Our Case Number: ABP-316828-23

Re: Tallaght/Clondalkin to City Centre BusConnect Core Bus Corridor Scheme.
Tallaght/Clondalkin to Dublin City.

Submission on the proposed
Tallaght/Clondalkin to City Centre Core Bus
Corridor Scheme

Figure 2.0- Showing Location of Proposed Bus Connects Works and Implications for the Maxol Station.

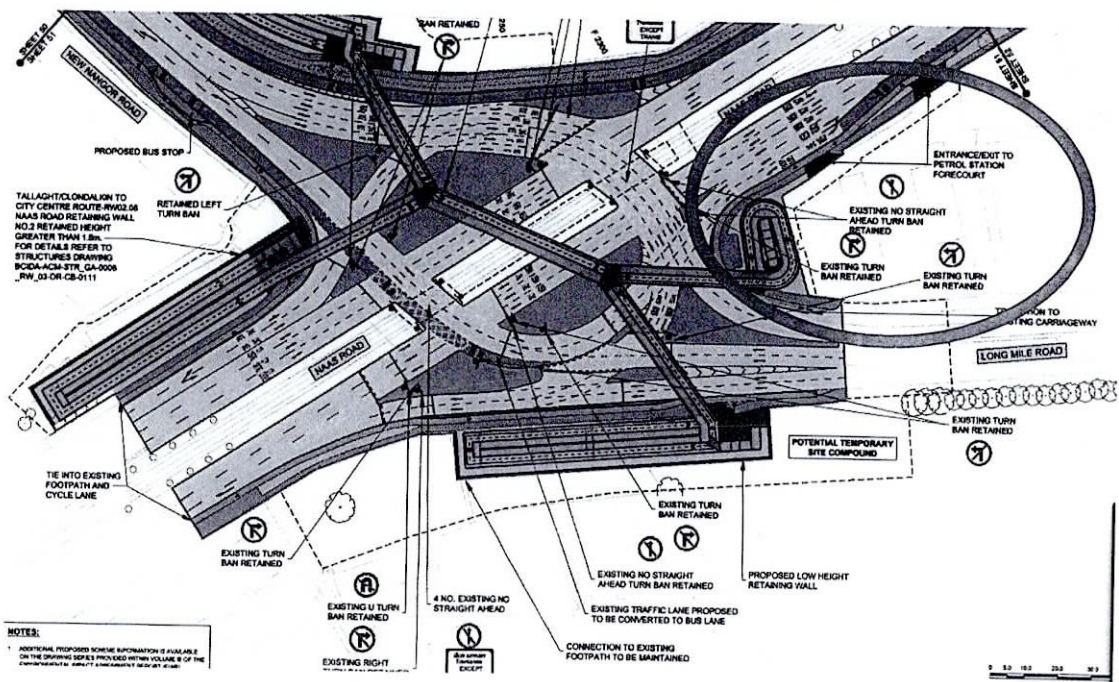
1.1 This submission has been prepared in response to the invitation by the National Transport Authority to make submissions or observations on the proposed 'Tallaght/Clondalkin to City Centre Core Bus Corridor Scheme'. The Scheme forms part of the Bus Connects project for the city. This submission is specifically related to the section 6 of the Scheme: the junction between the Long Mile Road (R110), the Naas Road (R810) and the New Nangor Road (R134). Drawing sheet no. 51 refers (Figure 2.0 below). The submission is made on behalf of Maxol Ltd.

2.1 The site of concern in this submission is that of a petrol filling station that is situated at the road junction between the Long Mile Road and the Naas Road. The petrol filling station has vehicular entrance and exit points along both road frontages. It is proposed to construct a pedestrian and cycle bridge across the complex junction. To facilitate access to this overbridge, four ramp structures are proposed adjacent to the road junction. One of these is a proposed curved ramp that is proposed to be constructed on lands that form part of the petrol filling station site. These lands currently do not form part of the petrol filling station itself and form a grassed area. However, they are immediately adjacent to underground fuel tanks. The ramp structure is one of four ramp structures to be built in order to facilitate the difference in level between the cycle lanes and the overbridge.

4.1 The proposed curved ramp structure would result in a significant scale structure that would be right in front of the petrol filling station. The ramp structure would not only reduce the visibility of the petrol filling station but also detract from the visual amenity of the area. While the road junction is not a piece of visual beauty, it is an important traditional landmark in the city of Dublin and the petrol filling station forms a clear and distinctive visual landmark marking the well-known V-shaped junction between two important radial routes into the city.

5.1 The construction of the proposed curved ramped bicycle/pedestrian route requires the acquisition of lands that currently form part of the petrol filling station. The permanent take line is right up to the back of the existing petroleum vent stack, the Vapour recovery pipe and the Offset Fill delivery points. These elements are all classed as within the hazard zones and are subject to minimum dimensions from buildings, sources of ignition and public roads and footpaths. As the proposed cycle track and footpath bridge would be classed as public footpath in this situation, there are clear health and safety implications arising from the proximity of the proposed curved ramp structure to the petrol filling station infrastructure. Where currently a grassed area is provided to separate the footpath from the petrol filling station, this buffer would disappear.

5.2 In addition, there are concerns about the level of the proposed curved ramp in relation to the vent stack. Under regulations, the vent stack must be 4.5 m above the ground level under regulations.

The concern here is that a lighted flame or cigarette at that level would be a danger. These issues appear not to have been addressed in the Environmental Impact Assessment Report (TBC).
